Courtyard enclosure study · closing the conditioned house around the open courtyard · Taif / Palm House V7.1

Design review Y-01 (critical) · 30 Oct 2026 · the windows follow `docs/DESIGN_LANGUAGE.md` (black steel, divided lites)

DECIDED: option A (owner, 30 Oct 2026, applied in V7.0): the projection 1.55 m, B3 / R11 / C21–C23 at x 5.80, W1 / W2 / W3 as in § 2. The "now" column below is the V6.3 state (edge x 5.60), kept as the record of the comparison.

Plans of the gallery strip, first floor · now / A / B · the sky opening and the void · about 1:115 on A4

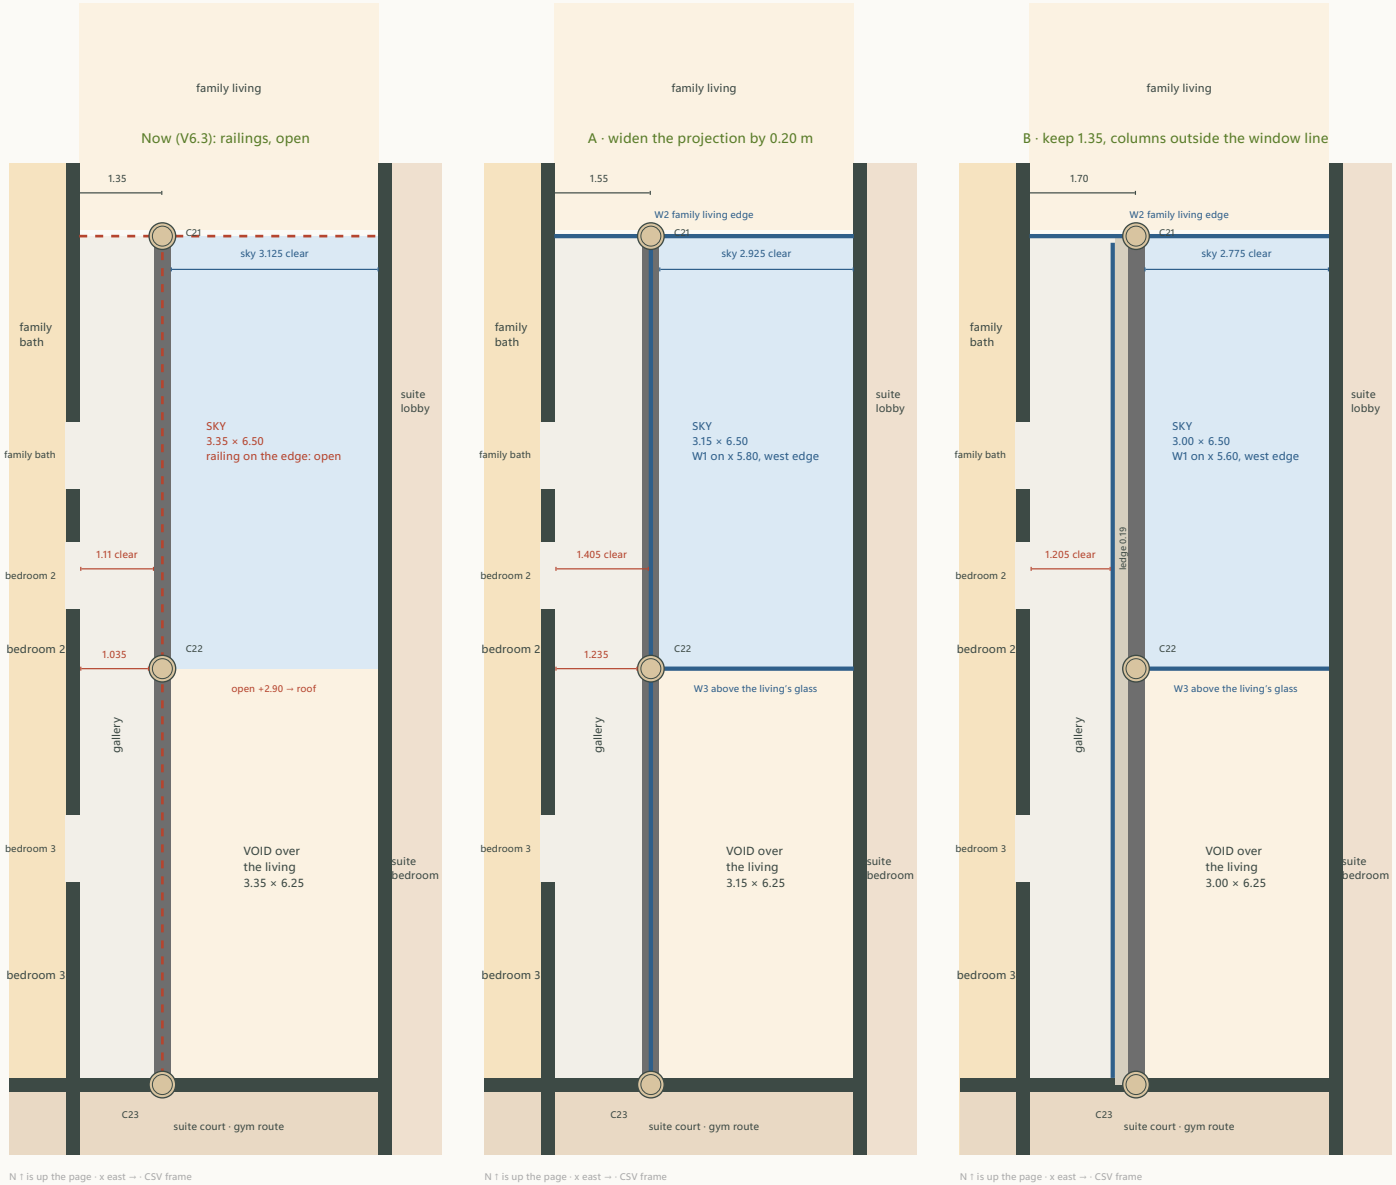
Today the gallery is 1.11 m clear between the rooms' finished wall face (x 4.365) and the upstand of B3, and 1.035 m at the three stone column sleeves (Ø0.4). A window on the line changes little by itself; the columns are the problem. Two ways to reach 1.20 m:

Dark: walls and the edge beam B3 (0.25 wide, upturned 0.30 above the slab). Blue lines: the new steel windows W1 / W2 / W3; red dashed: the open railings of today. Columns: the stone sleeve Ø0.4 round the Ø0.3 core. In B the beam and the columns leave the window line and a 0.19 m ledge lies between the glass and the beam (capped in stone, falling to the courtyard). The gallery doors are the V6.3 1.00 m openings.

4 · Recommendation: A **A** keeps everything on one line: the beam, the columns, the window and the railing base are the same element, the gallery is 1.405 m clear and 1.235 m at the columns, the sky loses 6 % of its area and stays 3.15 m wide on axes. **B** reaches 1.20 m with no margin (1.205 m), narrows the sky more (3 m: the beam and the roof edge must follow the columns), and adds a 0.35 m ledge outside the glass that must be waterproofed, capped and kept clean; its one real gain, free-standing columns in front of a glass wall, is a stronger colonnade image. If the owner wants that image, B is buildable; otherwise A. In both, the two-storey columns, the upturned B3 and R11 stay as decided (X8); only their x changes. **Study checks passed** (7)

Sections through the courtyard (y ≈ 10, looking north) · A and B · about 1:105 on A4

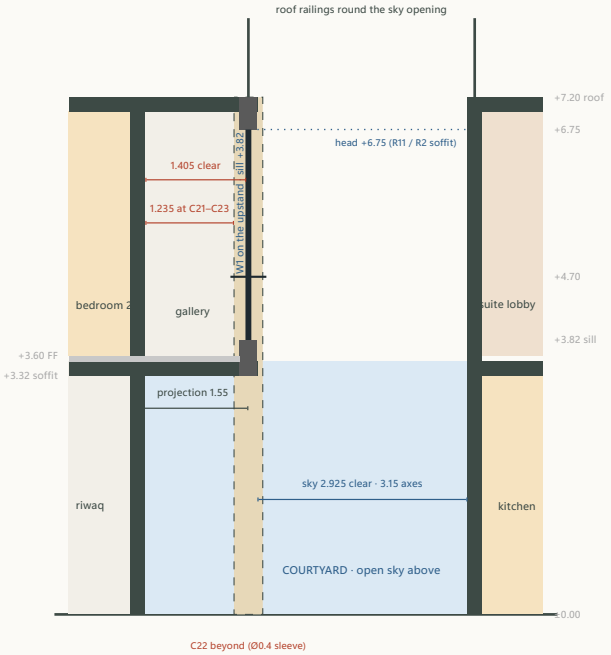
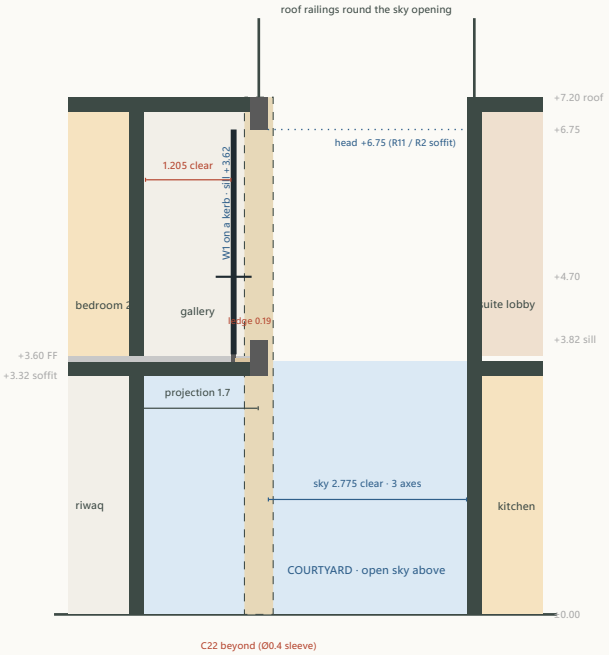
Dark: walls, slabs, the roof; grey: the upturned edge beam B3 (0.25 × 0.50 total, 0.30 above the slab) and the roof edge beam R11 above it; the dashed column is C22 (y 13.0) beyond the cut. W1 (heavy black line) sits on the upstand (A) or on a 0.10 m kerb inboard of it with a stone-capped ledge outside (B); its guarding transom at +4.70, its head at +6.75 under R11.

- **B:** B3, R11 and C21–C23 move 0.35 m east to x 5.95 the slab bay becomes 1.7 m with the window line 0.35 m inboard of the beam on a 0.10 m kerb; the ledge between the kerb and the upstand is waterproofed and capped (stone, falling out). The columns stand free in the courtyard and in the void: C22 is a free column in the living's courtyard glass line, 0.35 m in front of the upper window W3 (W3 then runs behind it, from the W1 line at x 5.6 to the kitchen wall, 3.25 m). Alternative B2 (not recommended): B3 stays at x 5.6 and reaches the columns at x 5.95 on short corbels; two lines of concrete for one edge.

- **A:** B3, R11 and C21–C23 move 0.20 m east to x 5.8 the projection slab bay becomes 1.55 m (slabs-ff row "the projection"), the roof strip over the gallery 1.55 m (slabs-roof); C22 stays the pier in the living's courtyard glass (now at x 5.8), C21 in the women's majlis glass, C23 in the living's south wall; the spans (6.5 / 6.25) are unchanged, R2's west end lands on C22 at x 5.8. The sky opening is 3.15 × 6.5 m.

W1 · the gallery line seen from the courtyard and the void (looking west) · option A · 1:70 on A4

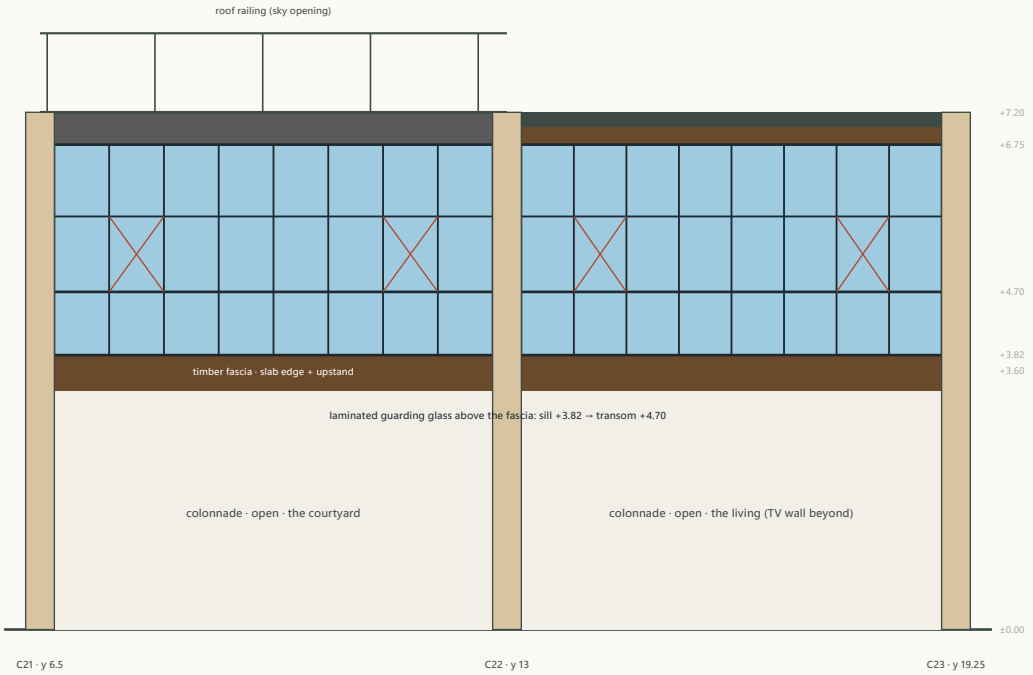
V7.1 (owner, 31 Oct 2026): semicircular heads and the courtyard arcade. Every enclosure window gets a semicircular (Roman) arched head in black steel with divided lites, the arched head fixed, the rectangular part below with the operable lites; the sill and the guarding transom (+4.70) as in § 2. **W1:** six arched windows 1.60 m wide on the gallery edge, three per column bay, sill +3.82, springing +5.80, crown +6.60, 0.15 m of wall below the R11 / R2 soffit (+6.75): in the courtyard bay they stand over the three bays of the new arcade (y 6.783–8.383, 8.950–10.550, 11.117–12.717), in the void bay on three equal bays (13.242–14.842, 15.325–16.925, 17.408–19.008); the four casements sit in the lower parts. **W2:** two arched windows 1.30 m wide east of C21 (x 6.00–7.30 and 7.55–8.85), floor to the crown +6.60, springing +5.95; the strip x 4.25–5.80 of that edge is the family living's opening to the gallery's north end, no window. **W3:** one arched window 2.80 m wide (the whole space between C22's stone sleeve and the east wall; the brief said ≈ 3.0) over the living's courtyard glass, +3.32 to the crown +6.60, springing +5.20, the two motorised tilt lites in its lower part; 0.15 m of wall to the R2 soffit. **The arcade:** in the courtyard bay only, two slender honey-stone columns Ø0.25 on x 5.80 at y 8.667 and 10.833 (three equal bays of 2.167 m on axes) with three semicircular arch plates under the projection's soffit (+3.27): spans 1.84 / 1.92 / 1.84 m between the sleeves, springing +2.35 / +2.31 / +2.35, crown +3.27; decorative unless the engineer uses the columns (`studies/structure.typ` X18); the living bay keeps no arches. The columns stand 0.78 m clear of the sunken seating's west edge, 1.36 m clear of the riwaq door's swing line, 1.33 m from the riwaq glass face; the malqaf outlet is on the east wall. The courtyard reads as a two-tier arcade: three arches below, three arched windows above.

black steel, divided lites ≈ 0.75 wide · transoms at +4.70 (guarding) and +5.75 · red X = inward side-hung casements, two per bay (night mode, cleaning) · about 35.01 m² of glass · A · widen the projection by 0.20 m
